Submission to Transport Oriented Development Program

This submission is provided in response to the NSW Department of Planning, Housing and Infrastructure's exhibition of:

- The Crows Nest (St Leonards) Transport Oriented Development (TOD) Program accelerated precinct rezoning proposal exhibition (note: for the purposes of this submission Lot 4B is referred to as 4B Herbert Street).
- Pathway changes to support transport oriented development and residential housing delivery.

Figure 3 – Proposed Height – 4B Herbert Street

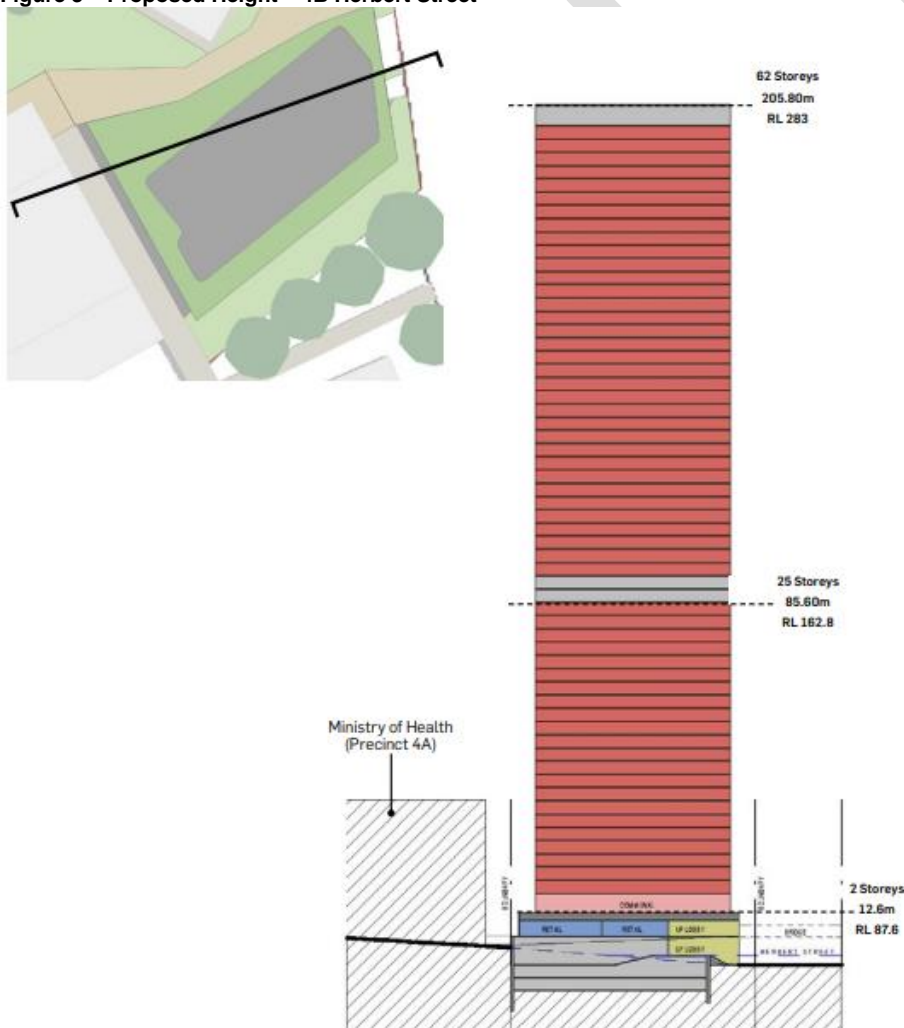
It is unclear how the proposed height on 4B Herbert Street achieves these objectives.

Consideration of a height response more sensitive to the surrounding sites and to the future skyline of the precinct is requested

Particularly given the proposed height, the proposed built form should be revised to ensure a more slender tower form is delivered on the site.

Figure 9 – 4B Herbert Street - Opportunity for additional planting

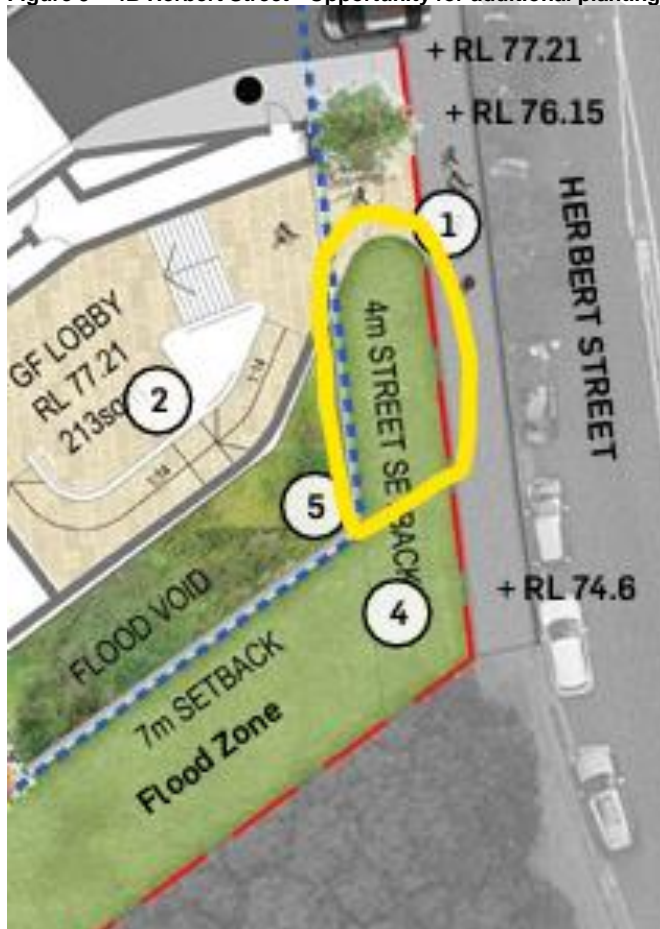
There is minimal planting volume along the street frontage to Herbert Street. Consideration should be given to trees and planting to present a greener appearance at street level and softening of the built form around the entrance.

At the ground and upper ground levels there are minimal trees proposed, with a heavy reliance on trees and green space within adjoining sites. Greater tree planting at ground level is encouraged.

The Landscape Plan and Design Guide should be updated to require additional planting where possible. Deep Soil areas should be utilised to maximise the tree canopy provided on the site.
